STAFF RECOMMENDATION 1902 5th Avenue North November 20, 2013

Application: New construction--infill
District: Salemtown Neighborhood Conservation Zoning Overlay
Council District: 19
Map and Parcel Number: 08108009700
Applicant: Larry Prater
Project Lead: Melissa Baldock, melissa.baldock@nashville.gov

Description of Project: Application is to construct a duplex on a vacant lot.

Figure 1. Lot at 1902 5th Avenue North.

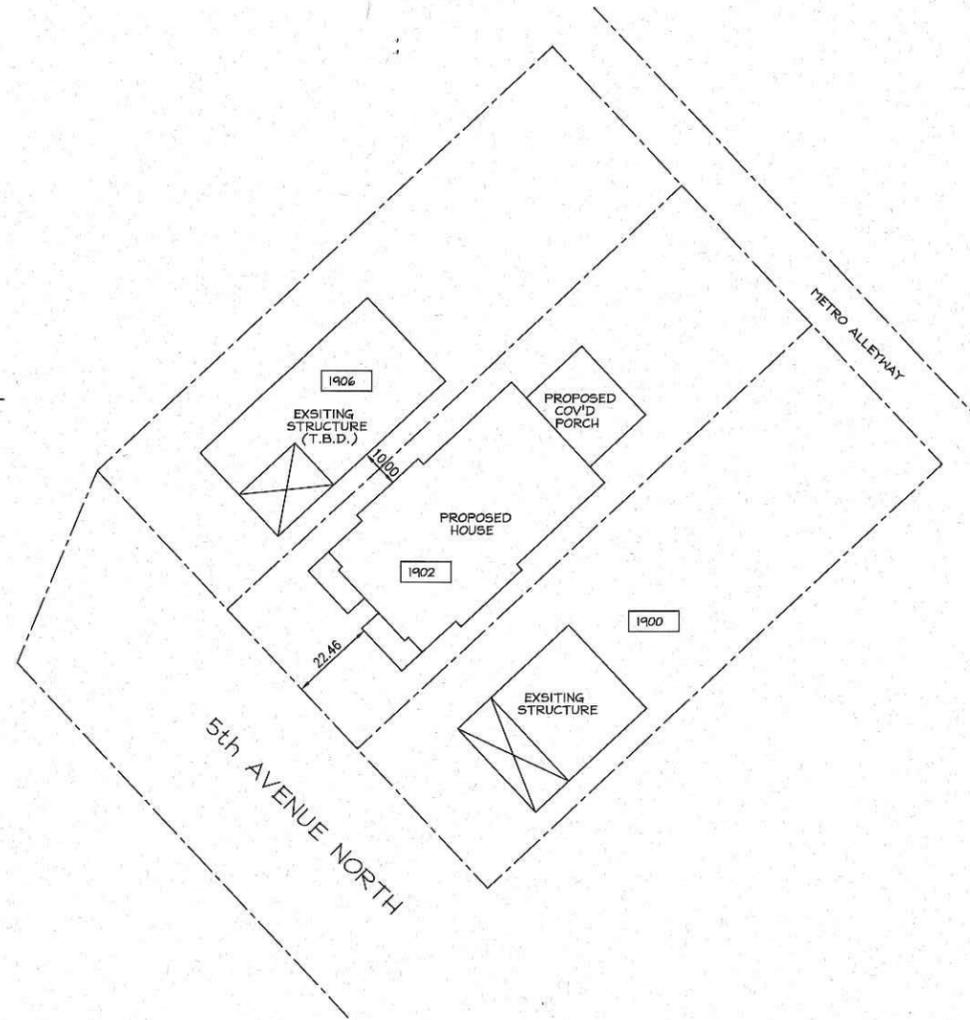
Background: 1902 5th Avenue North is a vacant lot (Figure 1). The building that was formerly on this site was demolished in in 1996, before the designation of the Salemtown Neighborhood Conservation Zoning Overlay.

FRONT ELEVATION

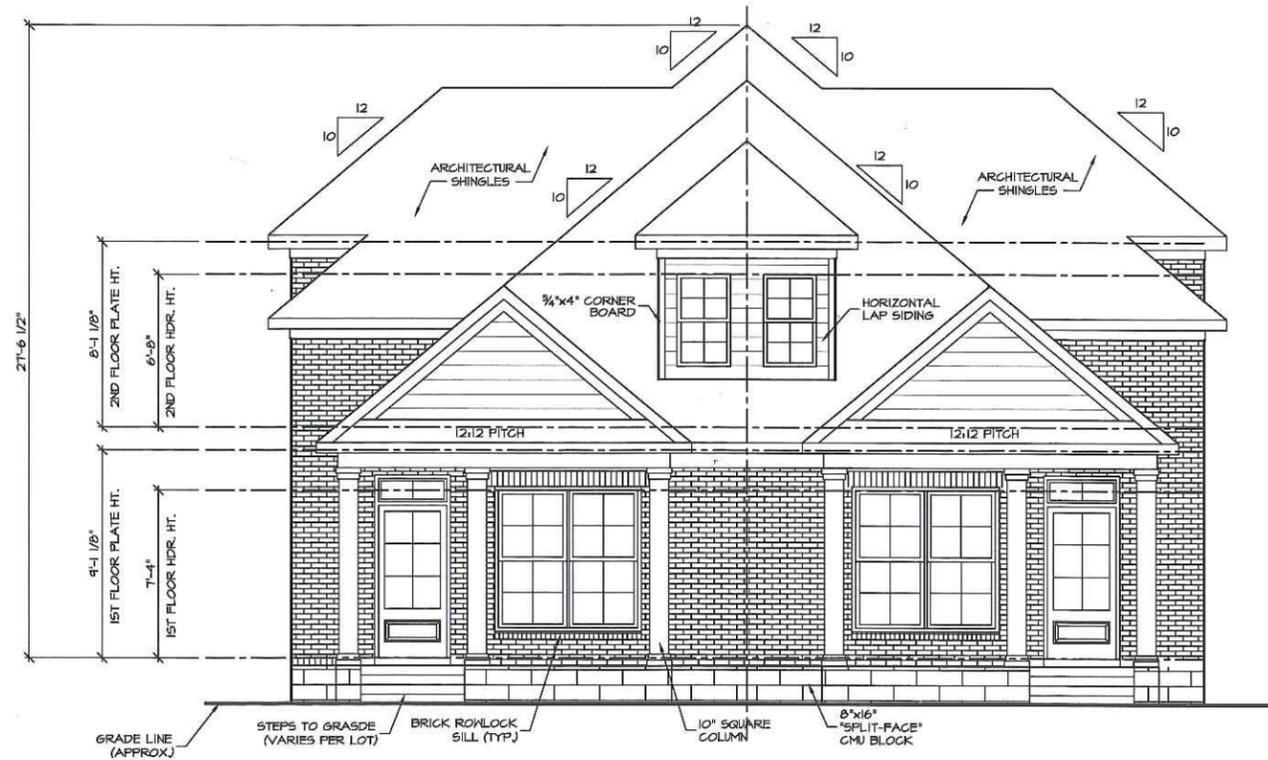
Materials. The primary cladding for the structure will be brick, and staff asks to approve a brick sample. Fiber cement lap siding is planned for the front porch gables and front and side dormers. Staff asks that the reveal be five inches (5") or less. The roof will be architectural shingles, and staff asks to approve the shingle color. The foundation will be split face concrete block. The materials of the porch columns and porch floor were not specified. Staff asks to approve these materials prior to purchase and installation. Likewise, the materials for the windows and doors were not specified, and staff asks to approve all window and door specifications. With the above-mentioned staff approval of materials, staff finds that the duplex's materials meet Section III.D. of the *Salemtown Neighborhood Conservation Zoning Overlay: Handbook & Design Guidelines*.

Proportion and Rhythm of Openings. The primary windows on the infill are twice as tall as they are wide, thereby meeting the historic proportions for window openings. Staff asks that a condition of approval be that all double and triple window openings have a four to six inch (4"-6") mullion in between them. On the front dormer, the two windows are approximately eighteen inches (18") apart, which is not typically seen in dormers. Staff asks that the windows be brought as close together as possible so that they can be a paired window with a four inch to six inch (4"-6") mullion separating them. In addition, on each of the side façades, the applicant has shown a faux window opening under a transom window. Staff asks that the applicant work with staff to develop a more typical window pattern in this location. With the addition of four to six inch (4" – 6") mullions, the reduction of the space between the front dormer windows, and the alteration of the faux windows on the side façade, staff finds that the duplex's proportion and rhythm of openings meet Section III.G. of the *Salemtown Neighborhood Conservation Zoning Overlay: Handbook & Design Guidelines*.

4. Double and triple window openings have a four to six inch (4"-6") mullion in between them;
5. The front dormer windows be brought closer together to be a paired window opening with a four to six inch (4"-6") mullion in between them;
6. The faux windows below transoms on the side façade be reconfigured to be a more typical window configuration;
7. The HVAC unit be placed at the rear, or on a side façade beyond the midpoint of the house.

PLAN NAME	COMMUNITY/LOT#	DRAWING NAME
	1902 5TH AVENUE NORTH	SIDE ELEVATIONS
SHEET NO.	A.6	
PLAN NO.

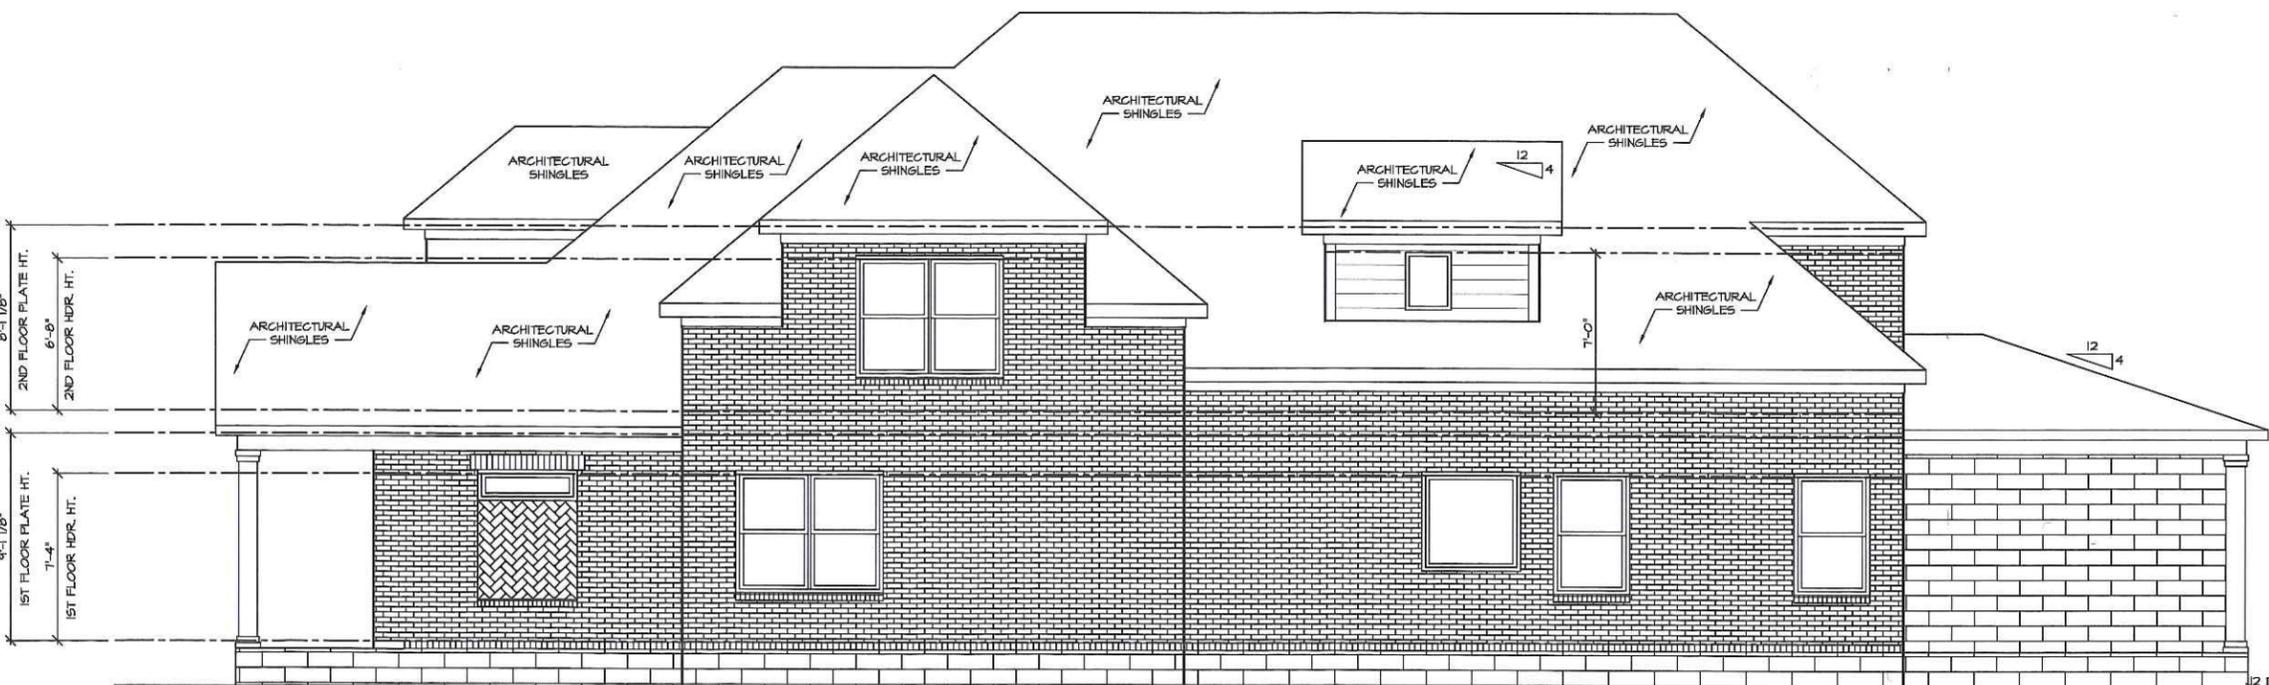
Height & Scale. The proposed infill will be one-and-a-half stories tall at the front, with a section that is two stories. At the front, the infill will have an eave height of approximately eleven feet (11') and a ridge height of approximately twenty-seven feet (27'). Approximately twenty-eight feet (28') behind the front wall of the house, the addition has a taller ridge height of twenty-nine feet (29'). By comparison, the houses in the immediate vicinity have heights that range from sixteen feet (16') to thirty-two feet (32').

The duplex at the front will be thirty-four feet (34') wide. Thirteen feet, four inches (13'4") behind the front wall of the house, the addition extends wider so that it is approximately thirty-nine feet (39') wide. After a depth of twenty-one feet, four inches, the duplex narrows again to be thirty-four feet (34') wide. By comparison, the houses in the immediate context have widths that range between twenty-one and thirty-six feet (21'-36'). While the proposed width is appropriate, staff notes that the wider portion of the infill has a tall eave height of sixteen feet (16'). This tall eave height so close to the front of the duplex and wider than the rest of the structure is out of scale with the historic context. Staff asks that the applicant either reduce this eave height, or reconfigure the design so that the taller eave height occurs further back on the plan, thereby being less visible from the street.

Roof. The house's primary roof form will be a hipped roof with a 10/12 slope. The front porch gables will also have a 10/12 pitch, as will the front hipped roof dormer. Two shed dormers on the side facades will have a 4/12 pitch. Staff finds that the duplex's roof form meets Section III.E. of the *Salemtown Neighborhood Conservation Zoning Overlay: Handbook & Design Guidelines*.

With alterations to the eave height of the wider portion of the addition, Staff finds that the duplex's height and scale meet Sections III.A. & III.B. of the *Salemtown Neighborhood Conservation Zoning Overlay: Handbook & Design Guidelines*.

1. The wider portion of the house have a reduced eave height or be relocated to be more in keeping with the historic scale of the neighborhood;
2. Staff review and approve a brick sample, the asphalt shingle color, all windows and doors, and the materials for the front porch columns and porch floor;
3. The siding reveal be a maximum of five inches (5");
